FINAL ENVIRONMENTAL IMPACT REPORT

Wilshire Grand Redevelopment Project

Case No. ENV-2009-1577-EIR-GB

FINAL ENVIRONMENTAL IMPACT REPORT

Figure IV.B-34 – an older version of this Figure was erroneously used in the Draft EIR.

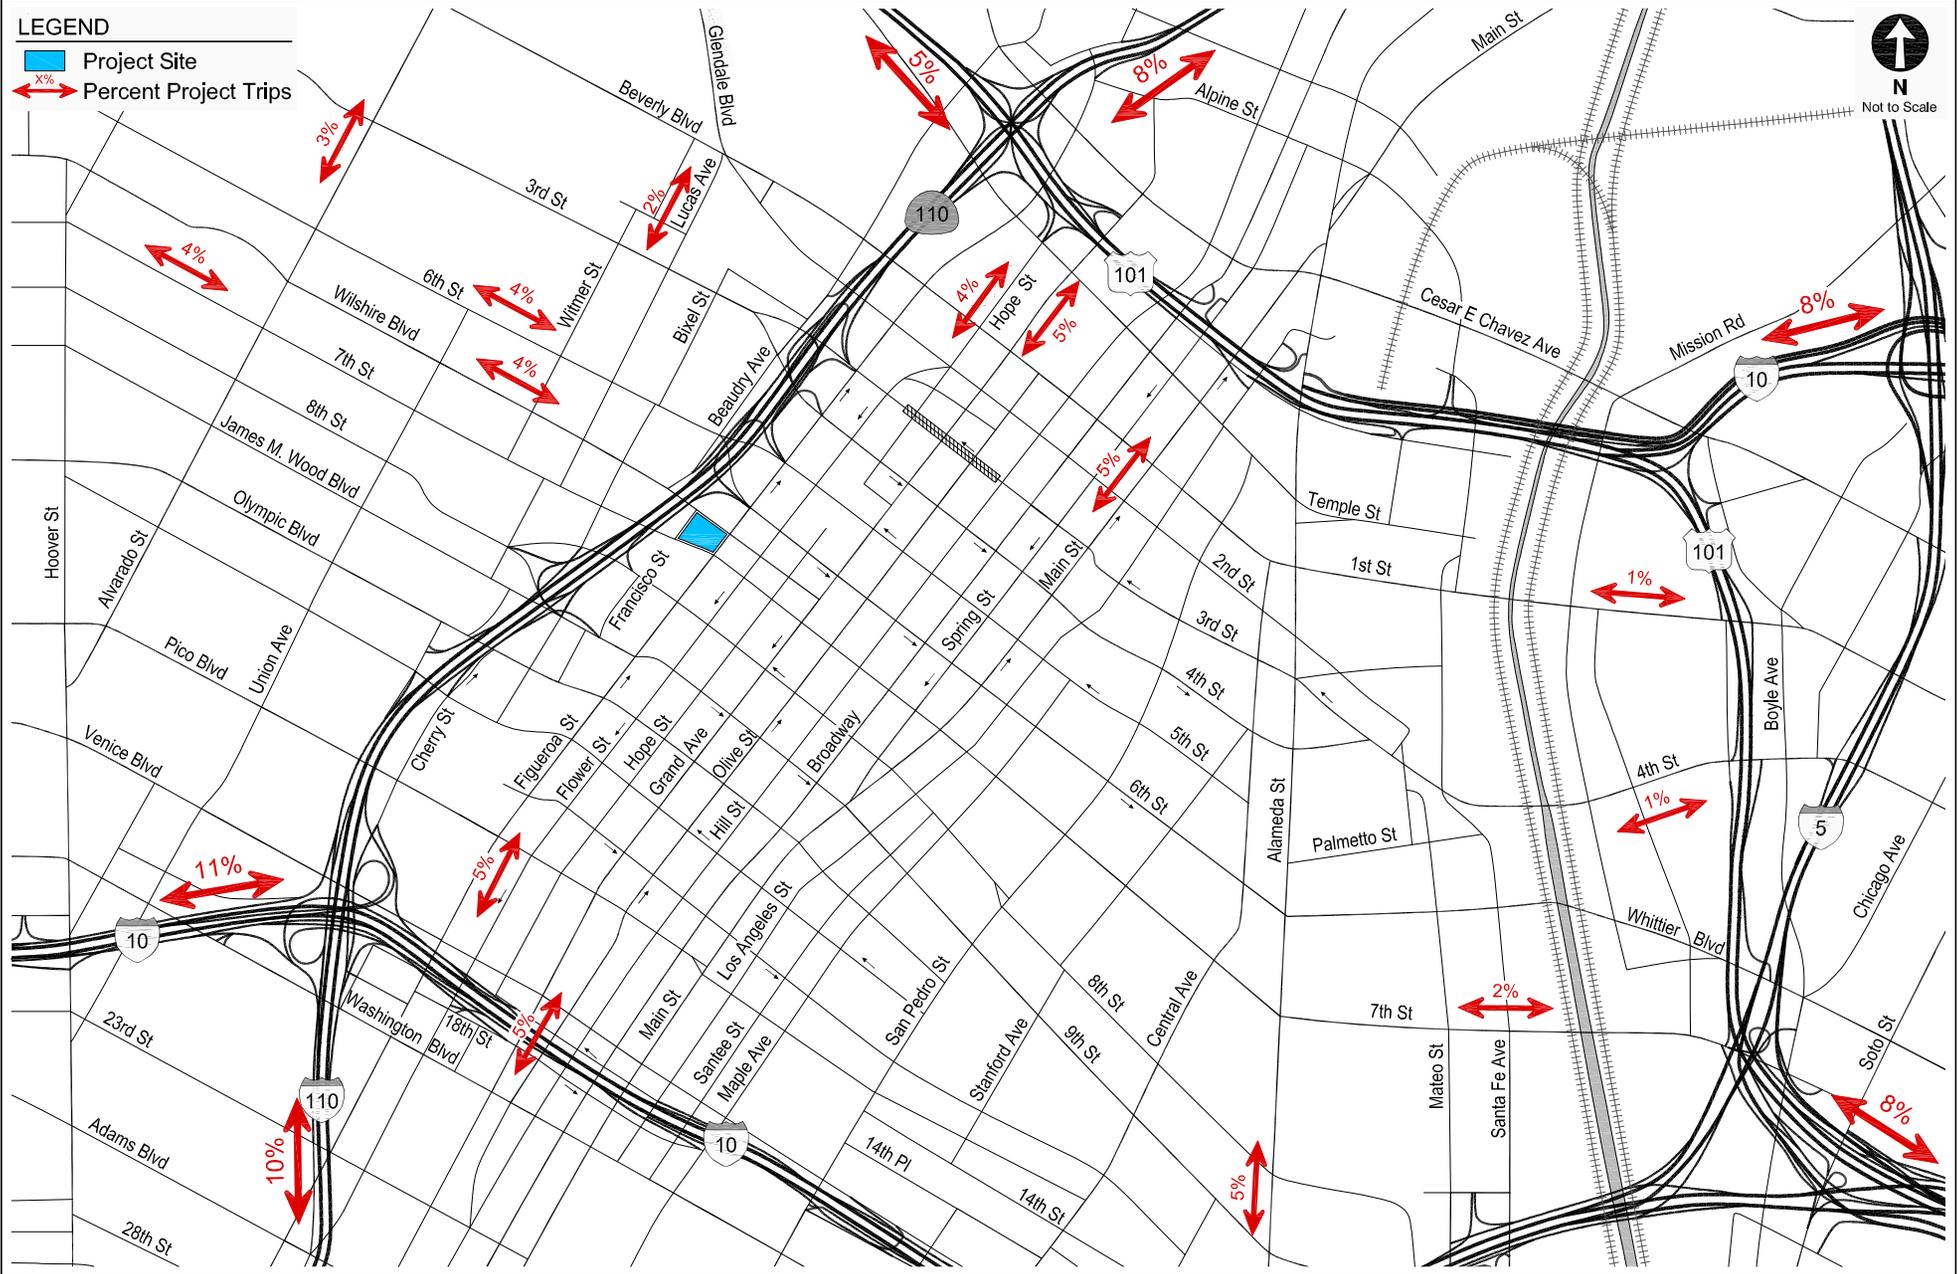
The commenter states that Figure IV.B-34 omits three significantly impacted intersections. An older version of the figure was inadvertently used in the Draft EIR. The list of significantly impacted intersections on Page VI-1 is correct. However, Figure 30 on Page 131 of the Transportation Study does identify the above intersections as significantly impacted. The updated figure is included in Section IV, Additions and Corrections.

The commenter states that page VI-1 of the EIR fails to include intersection 25 as significantly impacted during the morning peak hour. As mentioned above, an older version of Figure IV.B-34 was inadvertently used in the Draft EIR. Figure 30 on page 131 of the Transportation Study correctly identifies the significantly impacted intersections on page VI-1 of the DEIR. As shown in Table IV.B-26 on page IV.B-122 of the Draft EIR, the Project does not result in a significant and unavoidable impact at the intersection of Figueroa Street & 8th Street (intersection 25). Therefore, the list of significantly impacted intersections on Page VI-1 is correct.
